MSOX4104A-01

S E R V I C E N O T E

4000 X-Series Scopes

A replacement of the power supply cover is needed when the cabinet assembly is replaced.

New revision cabinet assembly (54709-64401)

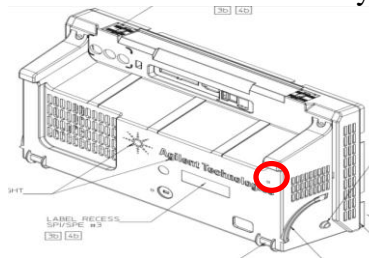
2. If the cabinet assembly is the new revision, proceed with repair as normal
3. If the cabinet assembly is the old revision
 - a. Replace the power supply cover (54695-00103) with new revision
 - b. Replace cabinet assembly as usual (54709-64401)
 - c. Insert screw (0515-0380) into the new screw hole on the cabinet assembly (circled below)
